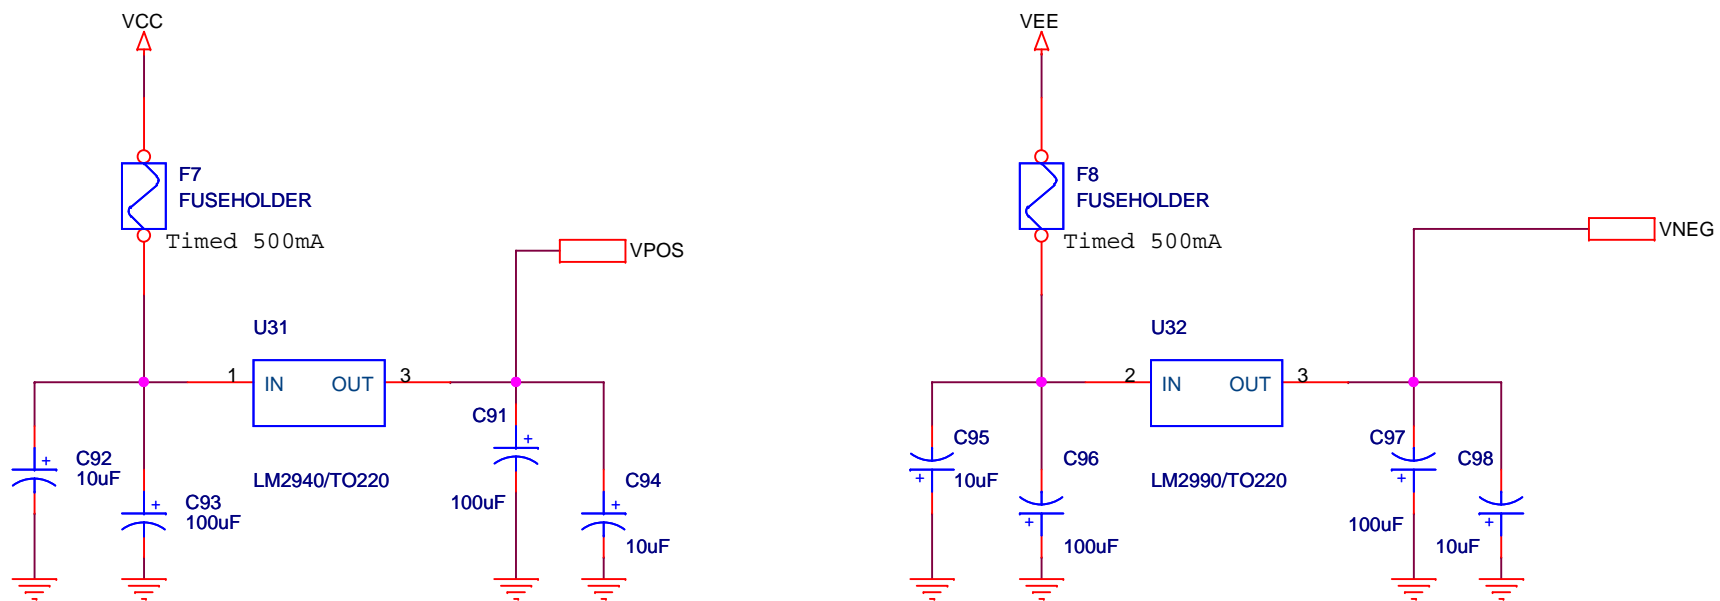
Added a 15V zener between pin 1 (Cathode) & 3 (Anode) of U25 in order to avoid a latch-up problem at startup  
 (Use + holes of C68 and C70)

C68, C67, C70, C71, C73, C74 not placed
